IN THE DRAWINGS

Corrected drawings are supplied herewith, each labeled as "REPLACEMENT SHEET".

FIG. 4

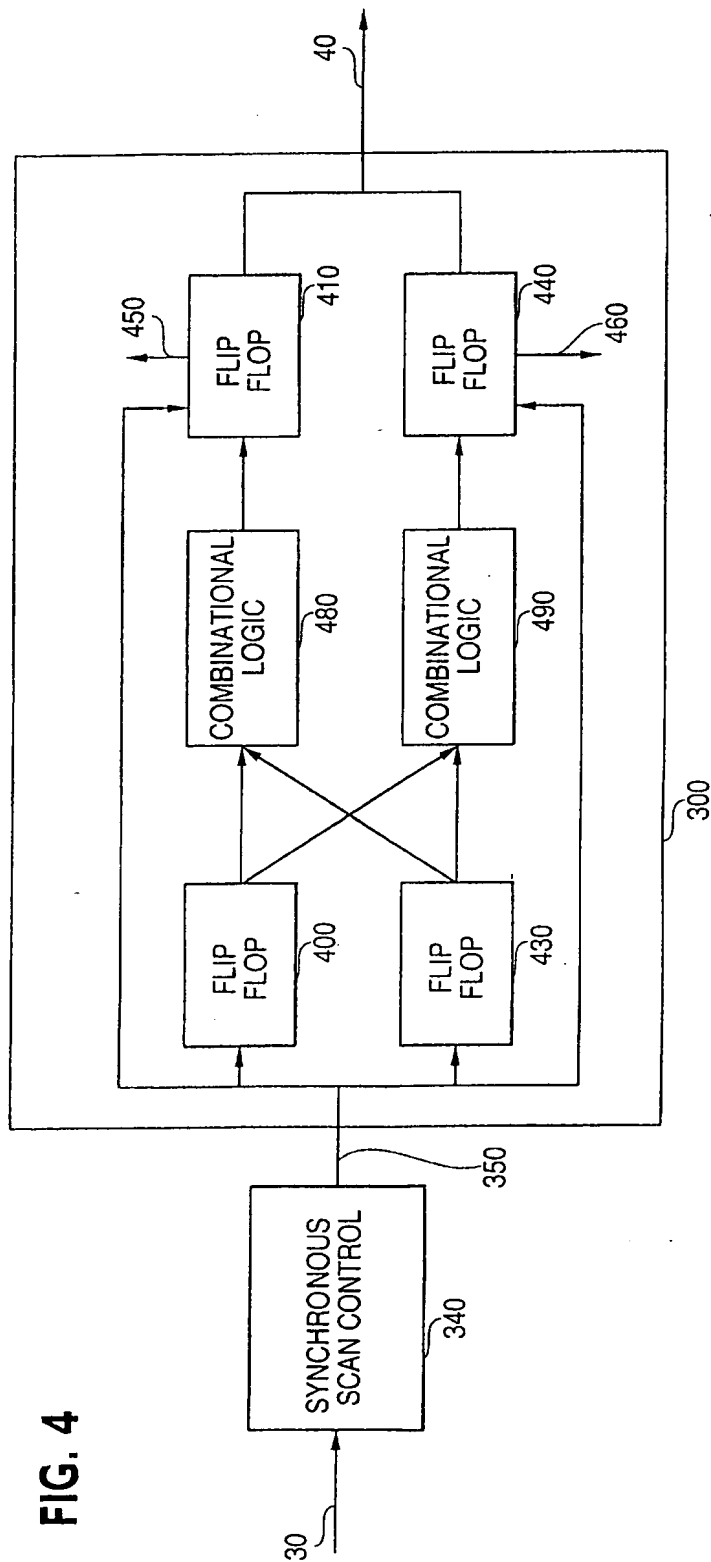
In FIG. 4 and FIG. 5, in block 340, the word "Synchrounous" above "Scan Control" has been replaced with "Synchronous". These changes are made to correct a typographical error and to be consistent with the Detailed Description. No new matter has been added.
